**LOST CREEK ISR, LLC**

**Re: Submittal of Responses to 4<sup>th</sup> Round Comments  
TFN 4 6/268**

**RESPONSES TO JULY 2010 WDEQ/LQD COMMENTS  
ON  
THE MAIN PERMIT DOCUMENT**

**for the  
LOST CREEK PROJECT  
Wyoming**

**FIGURE D6-27 b**

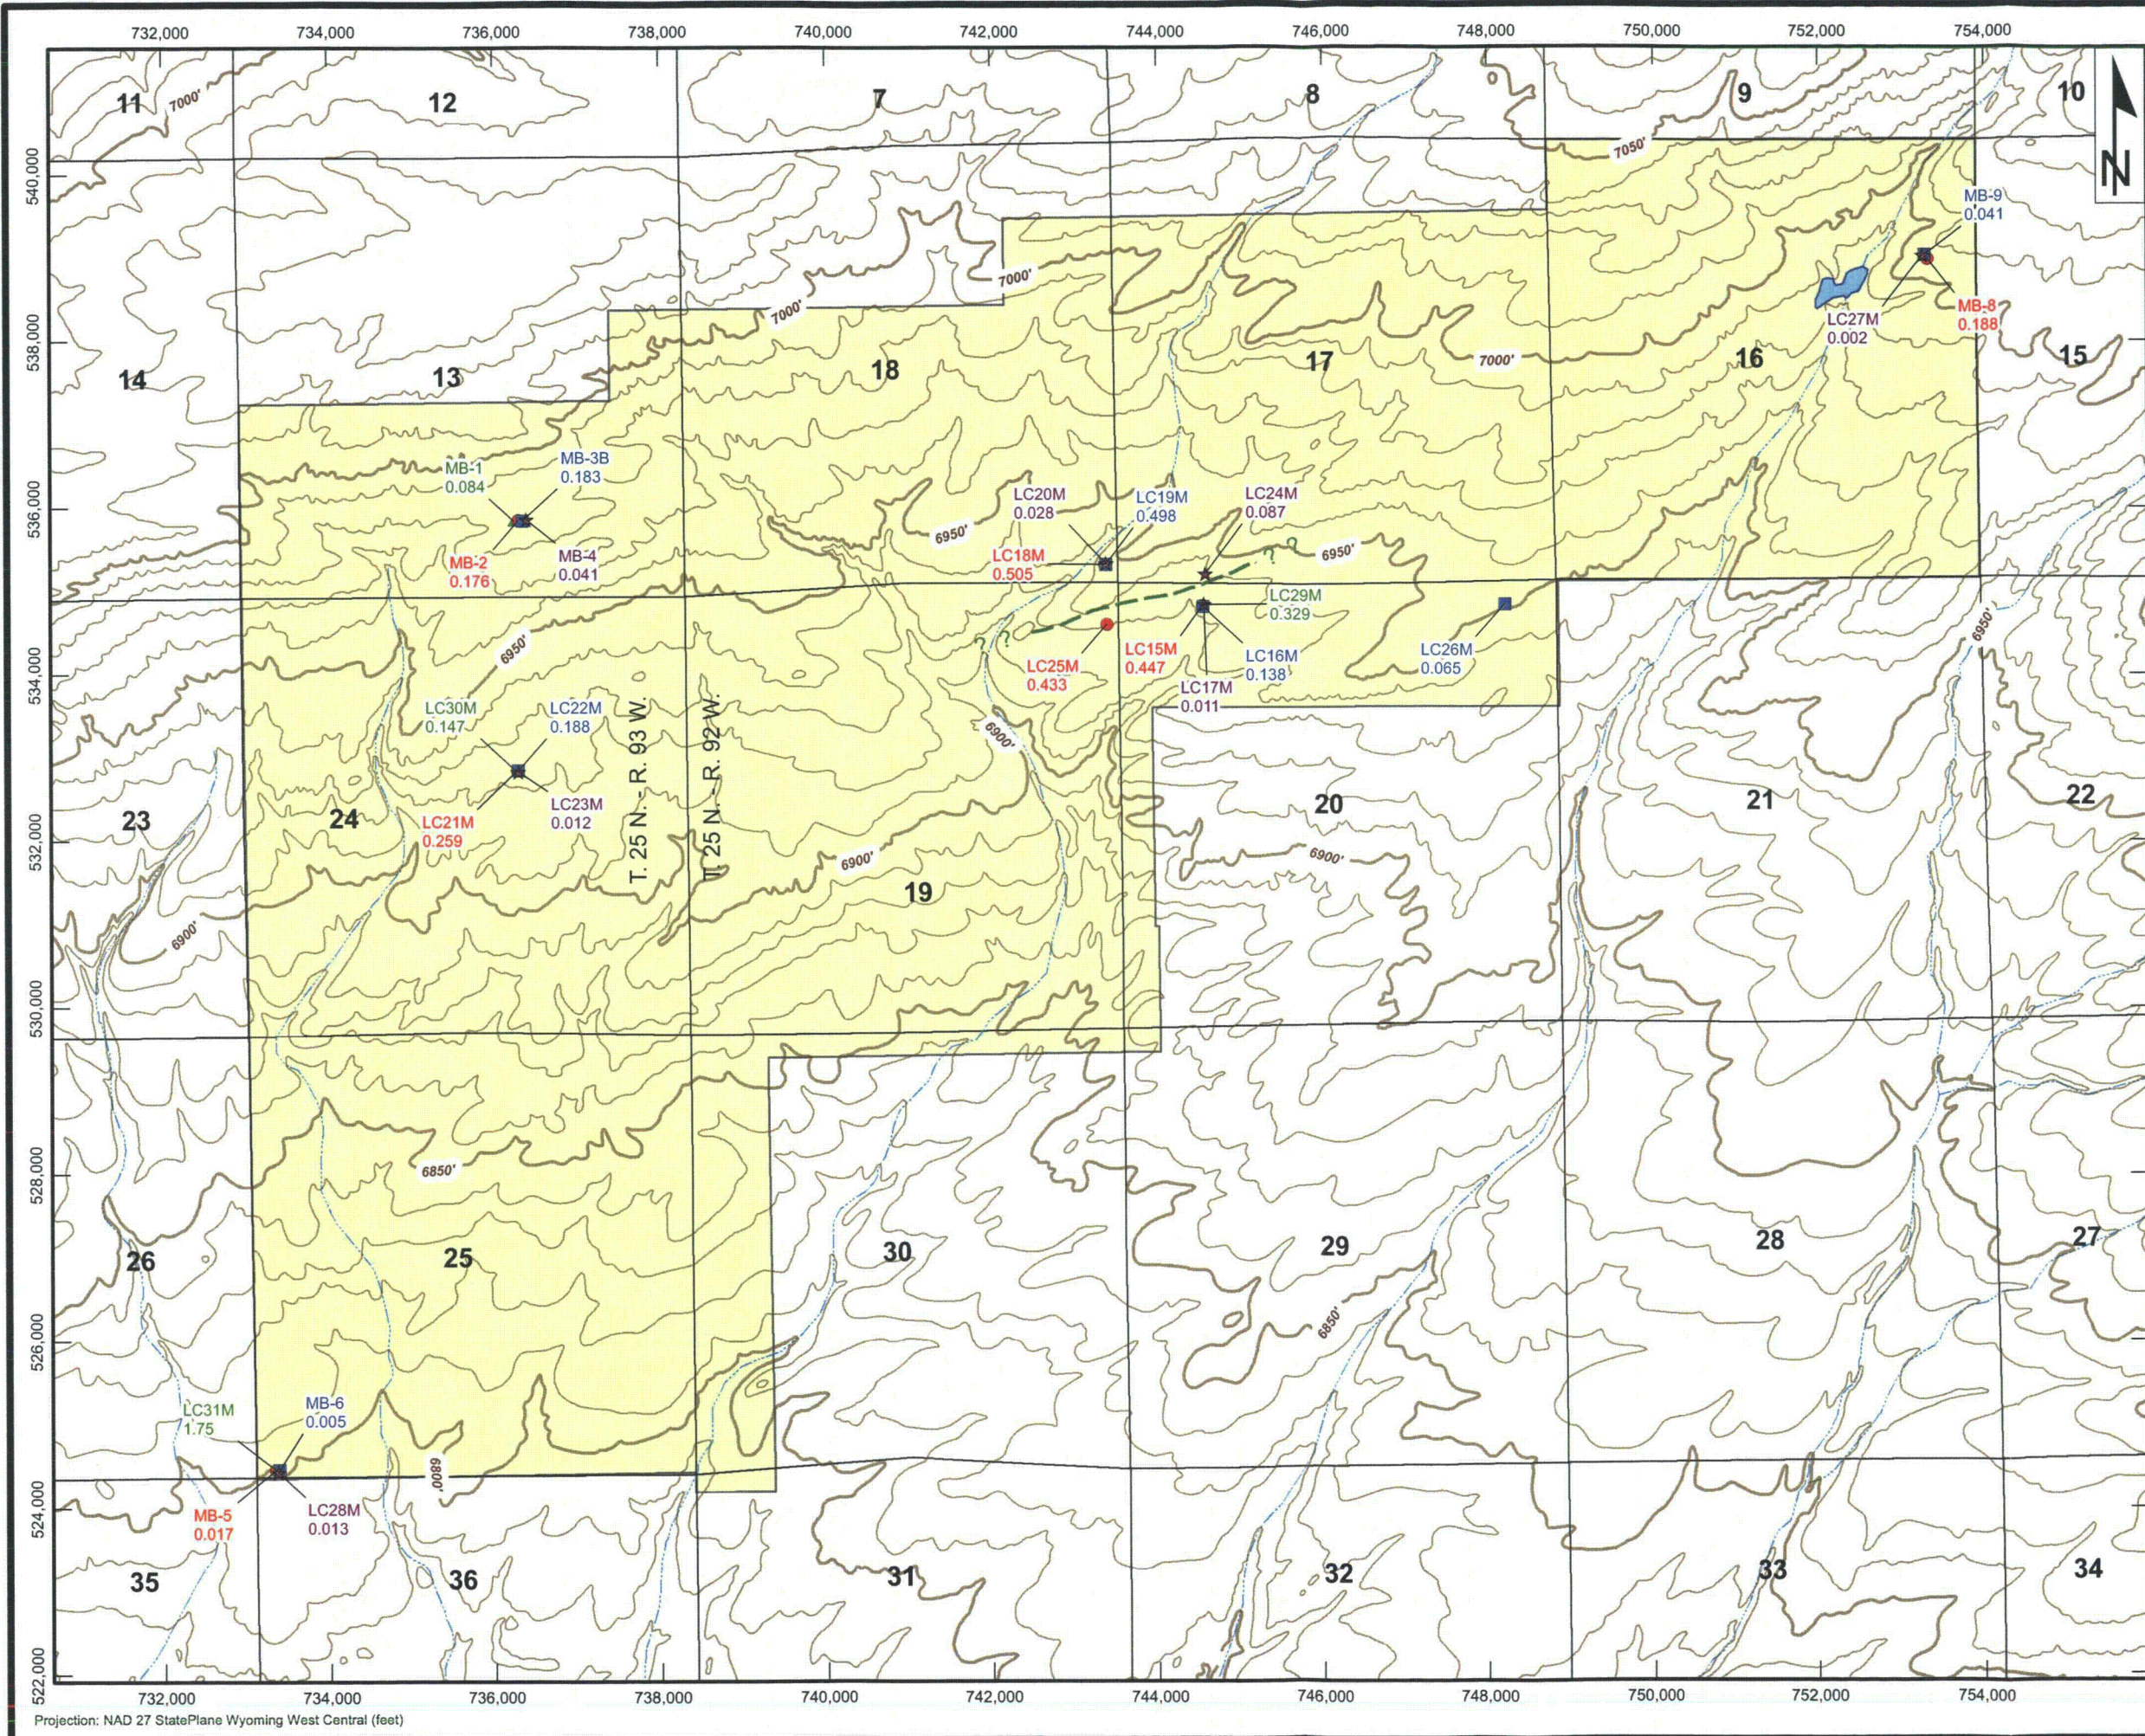
- 16) LQD (8/08) - *Figure D6-27a, Piper Diagram - Average Water Quality at Individual Monitoring Wells. The legend designates which well is represented by which symbol, and the wells are grouped by color, yet it does not indicate which horizon the wells are monitoring. Please add the horizon noted by each color. (The colors are not consistent with which formation they represent, i.e. other Figures use green to indicate the DE horizon wells, whereas the Piper diagrams use red).*

LQD (12/09) - *The diagrams will be updated once the data becomes available. This comment will remain open until that time. In addition, Comments 35, 36, and 37 have been dropped and are noted here. Table D6-15a and Section D6.4.2.2 will also need to be updated when the 2009 groundwater monitoring data is finalized and incorporated into the permit.*

Piper diagrams have been developed to compare groundwater quality between individual wells (**Figure D6-27a**) and between different aquifers (**Figure D6-27b**). The individual well comparison plots the average value for each of the wells for all of the samples analyzed. The piper diagram comparing different aquifers represents the average water quality for all wells sampled within individual aquifers (DE, LFG, HJ and UKM). Groundwater within the shallow Battle Springs aquifers beneath the Permit Area is a calcium sulfate to calcium bicarbonate type water. There is some variability in water chemistry when the wells are compared individually.
